**METROPOLITAN GOVERNMENT OF NASHVILLE AND DAVIDSON COUNTY**

**STAFF RECOMMENDATION**  
**305 Scott Avenue**  
**March 18, 2015**

**Application:** New construction-infill  
**District:** Eastwood Neighborhood Conservation Zoning Overlay  
**Council District:** 06  
**Map and Parcel Number:** 083020E90000CO  
**Applicant:** David Baird, architect  
**Project Lead:** Robin Zeigler, robin.zeigler@nashville.gov

A1.03

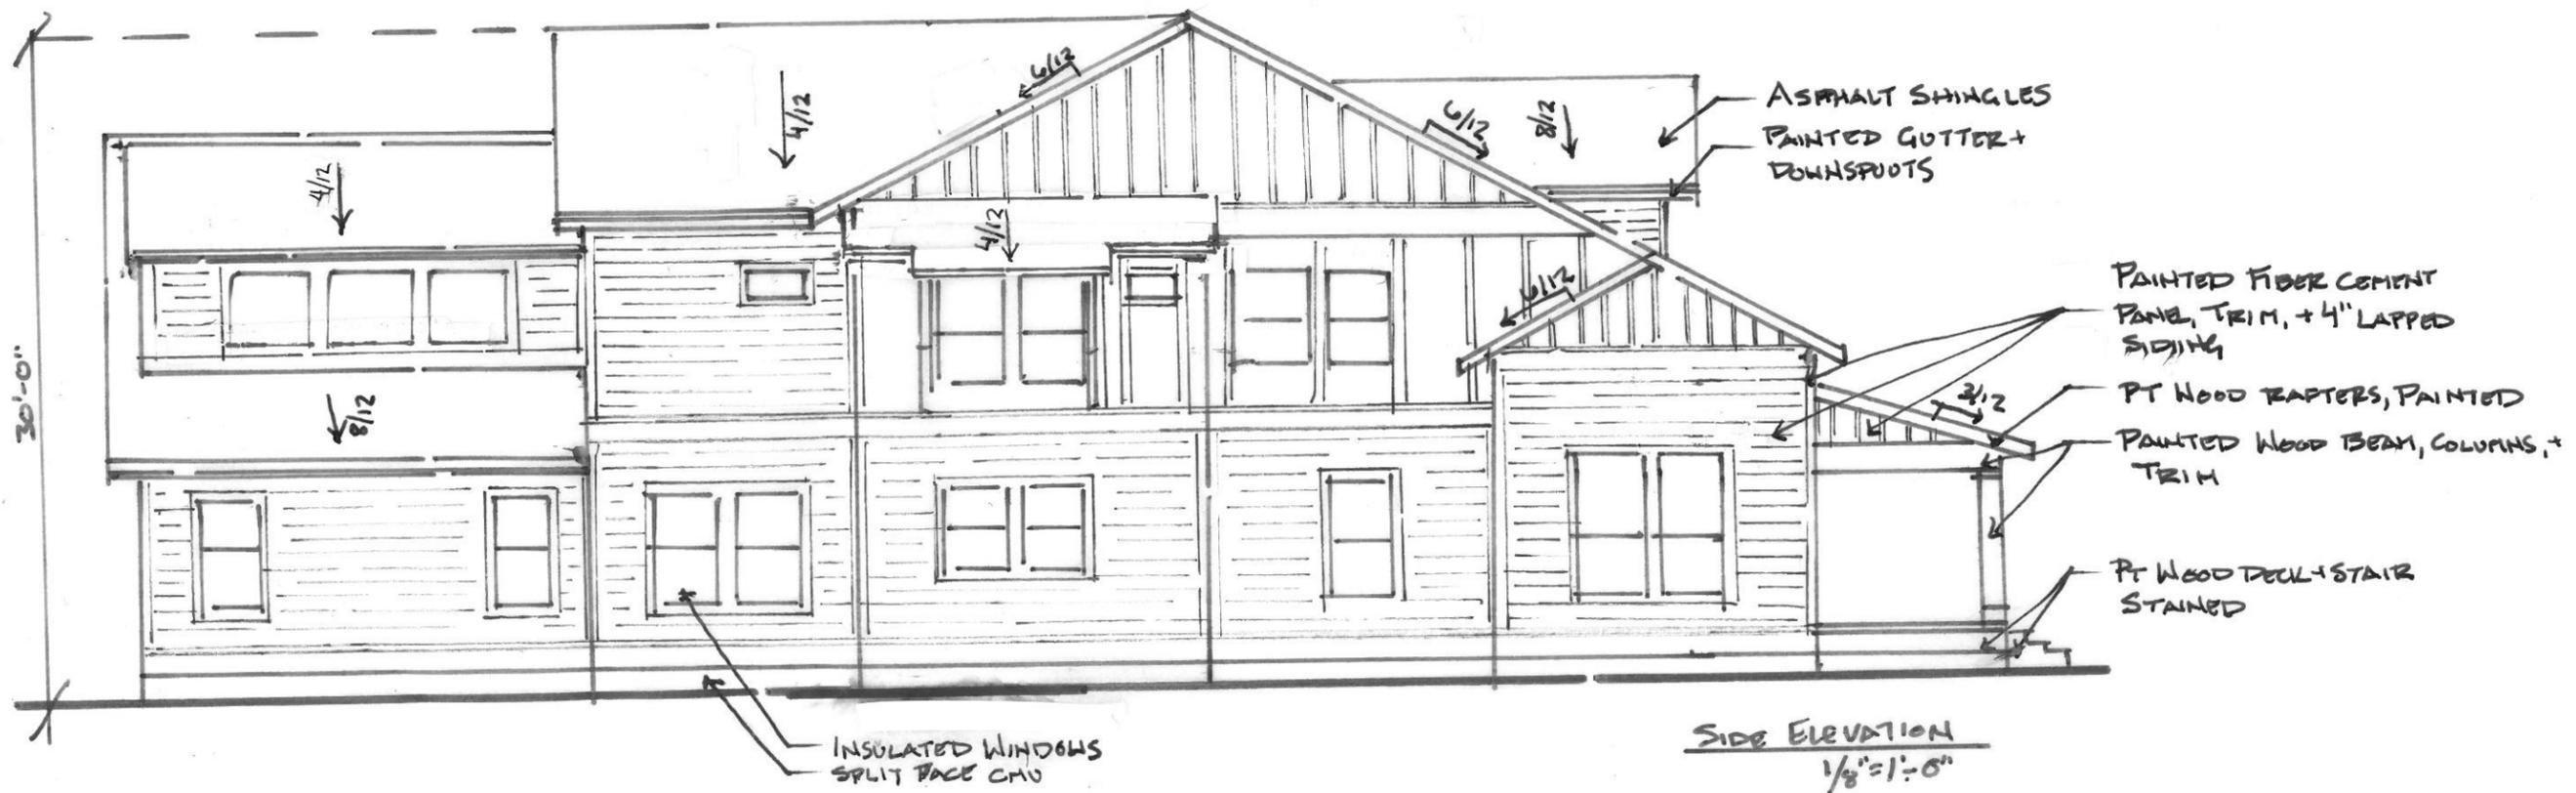
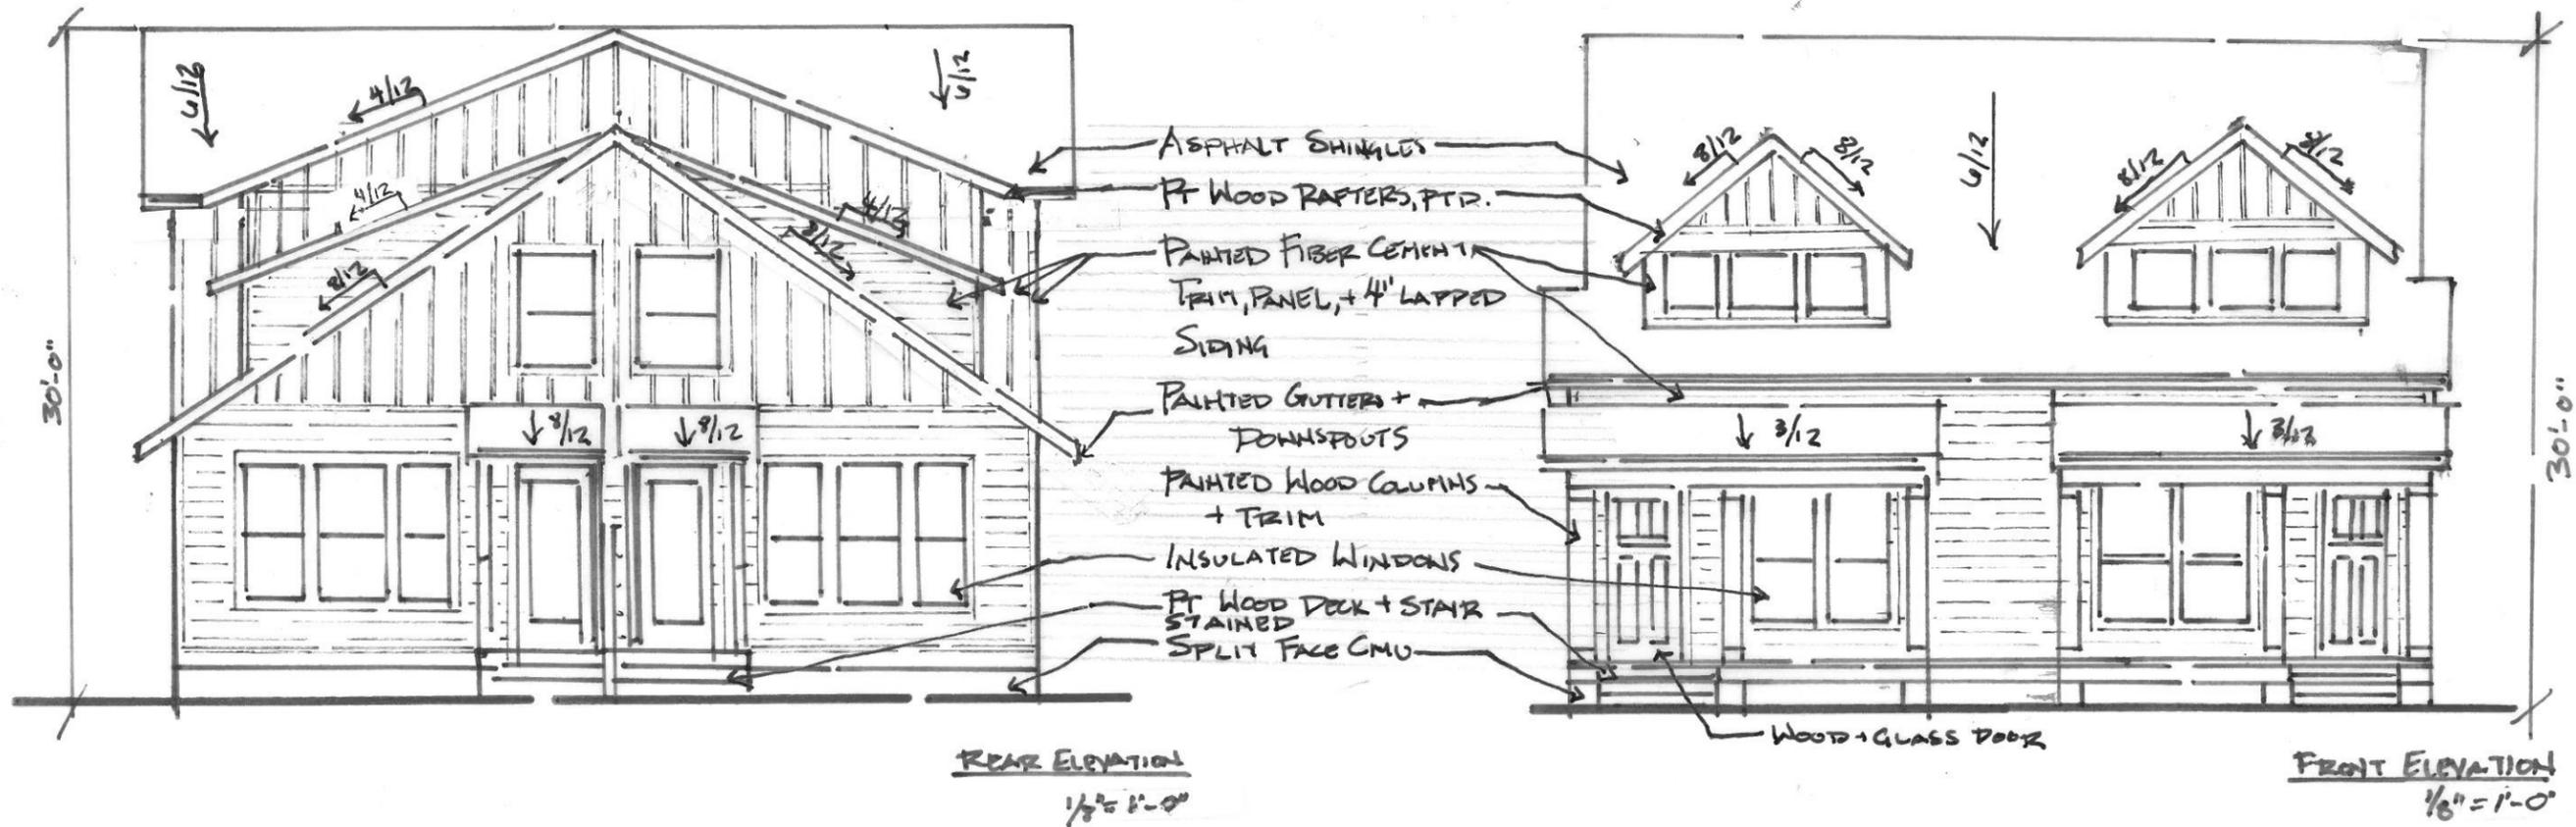
Roof form: The principle roof form is a side-gable roof with a 6/12 pitch and two front gable dormers with 8/12 pitches. The front porches have a 3/12 pitch. The roof forms are similar to neighboring historic buildings and have been approved in the past. The project meets section II.B.1.e.

A2.01

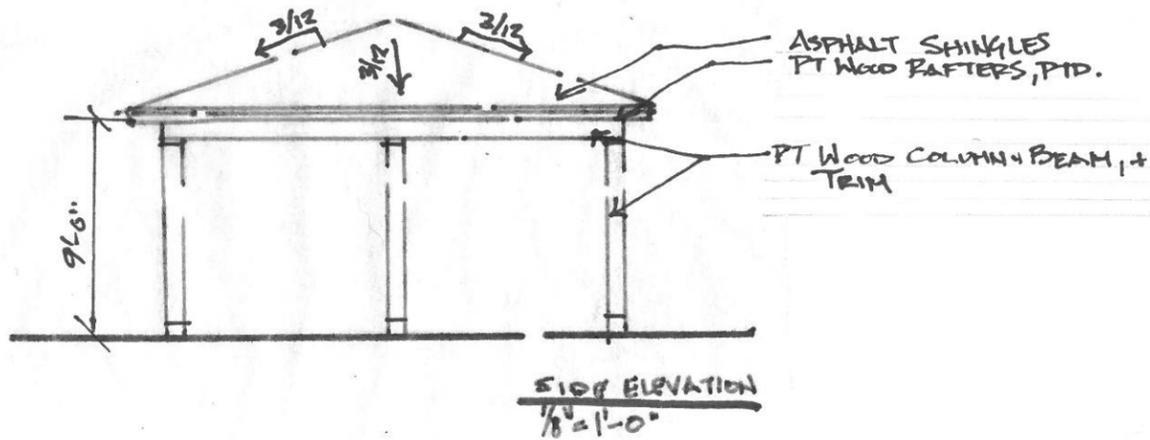
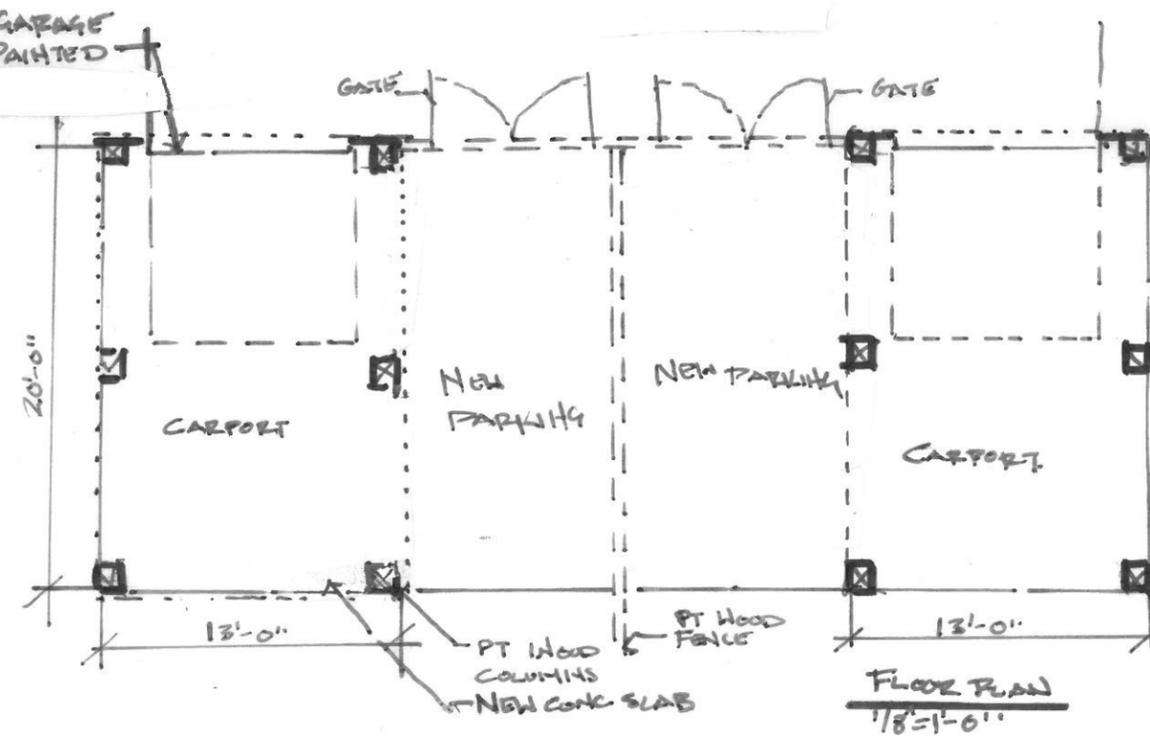
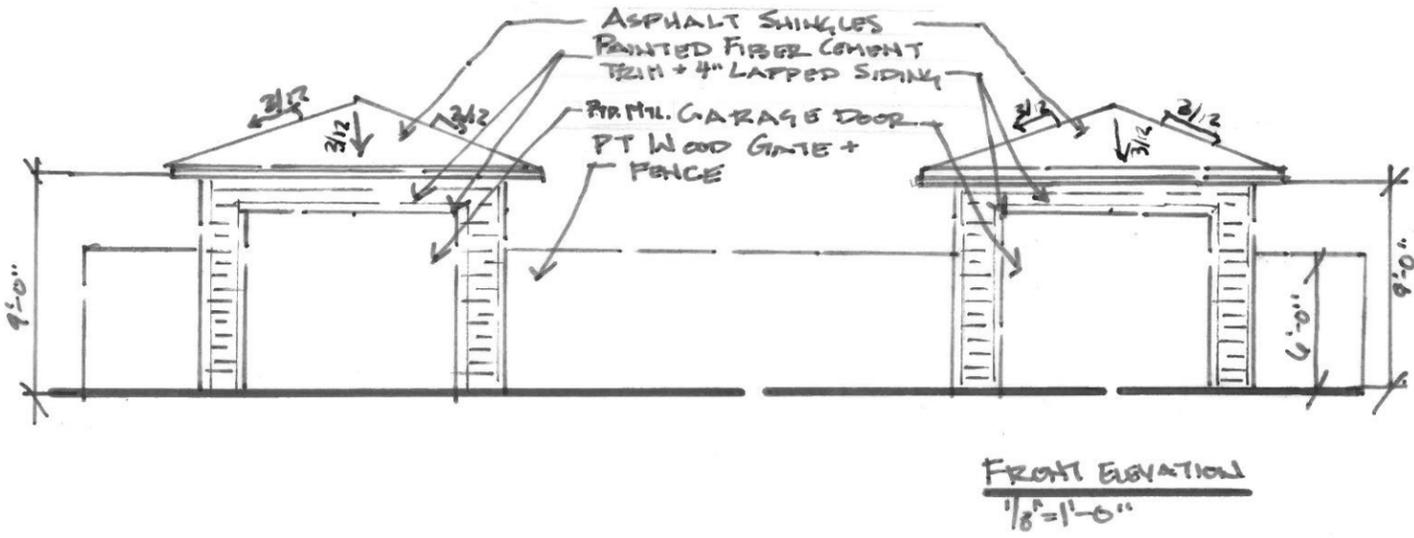
Height & Scale: The building is proposed to appear as one and one half stories, as seen from the street, and to be thirty-feet (30') tall, which is similar to the tallest historic building in the immediate vicinity and on a similarly sized lot. The proposed width of thirty feet eight feet and five inches (38' 5") is also similar to a couple of two-story homes in the immediate contextual area. The depth of the building at eighty-four (84') is far greater than the historic context; however, its massing is mitigated by stepping back portions of the side walls and by bringing the rear of the home down from a full two-stories to one and one-half stories. The drawings assumes a flat lot, which is not likely, therefore staff recommends review during construction to assure that the finished floor height be consistent with the finished floor heights of the adjacent historic houses. With this condition, the project meets section II.B.1.a. and b.

Materials: The roofing is asphalt shingles, the siding is fiber cement with a four inch (4") lap as well as board-and-batten, and the foundation is split faced CMU. Staff recommends review of the roof color. Staff recommends review of the windows, doors and garage doors, as these elements were not noted in the plans. The trim and porch elements are fiber cement and wood. There is a fence down the center of the property which will be six feet (6') tall and wood. The project meets section II.B.1.d

Proportion and Rhythm of Openings: The windows are primarily twice as tall as they are wide with some exceptions of smaller windows on the side where they will be minimally visible from the street. There are no expanses greater than ten feet (10') without an opening or other type of break. Staff finds the project's proportion and rhythm of openings to meet Section II.B.1.g.

- The finished floor height shall be consistent with the finished floor heights of the adjacent historic houses, to be verified by MHZC staff in the field;
- Staff approve the final details, dimensions and materials of windows and doors prior to purchase and installation;
- The HVAC shall be located behind the house or on either side, beyond the midpoint of the house; and
- Staff approve the roof color and masonry color, dimensions and texture.
